ADDENDUM

PROJECT : VAMC Lebanon

Plumbing Field Study, Project #595-14-177

JOB TITLE: PLUMBING DEAD LEG REMOVAL FOR LEBANON VETERANS AFFAIRS MEDICAL CENTER (VAMC)	DRAWING TITLE: THERMAL ERADICATION DETAIL		DRAWING BY: D. PFEFFER
	DATE: 08/25/15	PAGE SIZE: 8.5" x 11"	SKETCH NUMBER: SK-001
JOB NUMBER: 595-14-177		JOB NUMBER: 595-14-177

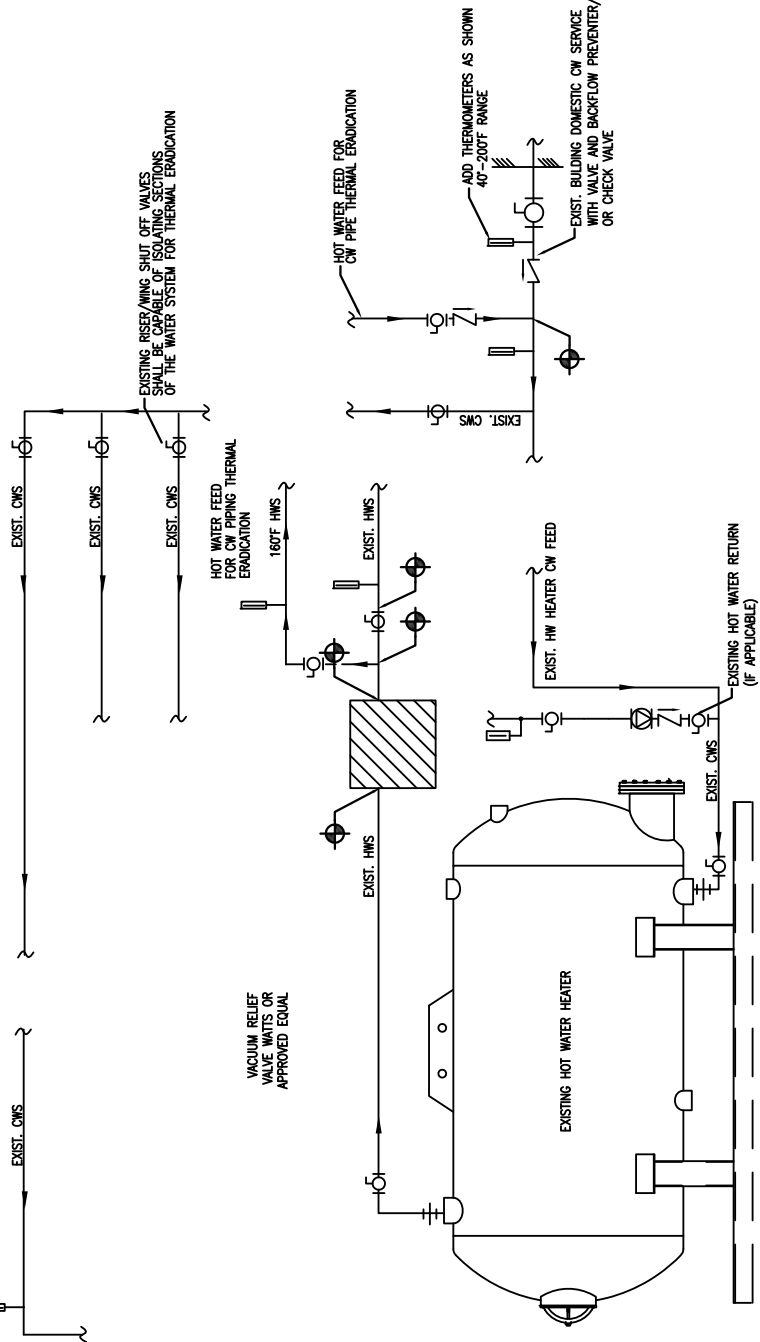
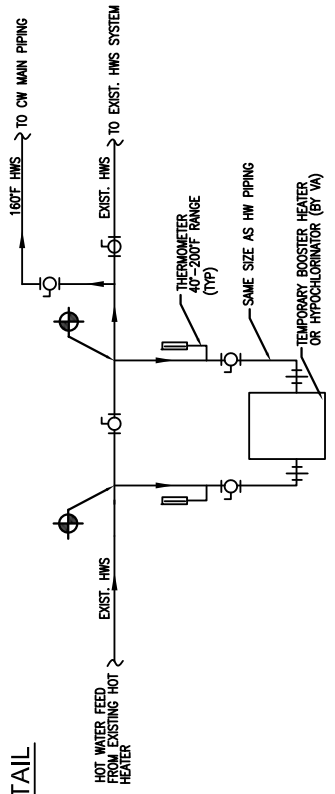
2. Drawing LB-PD-01 detail number 1 revised. See sketch SK-001 attached.

PROVIDE THERMOMETER AT MOST REMOTE CW FIXTURE FROM SOURCE FOR VERIFICATION OF HOT WATER TEMPERATURE DISTRIBUTION. LOCATE IN ACCESSIBLE AREA FOR VISUAL OBSERVATION

TYPICAL THERMAL ERADICATION MANUAL BYPASS DETAIL

TYPICAL TEMPORARY BOOSTER HEATER CONNECTION DETAIL
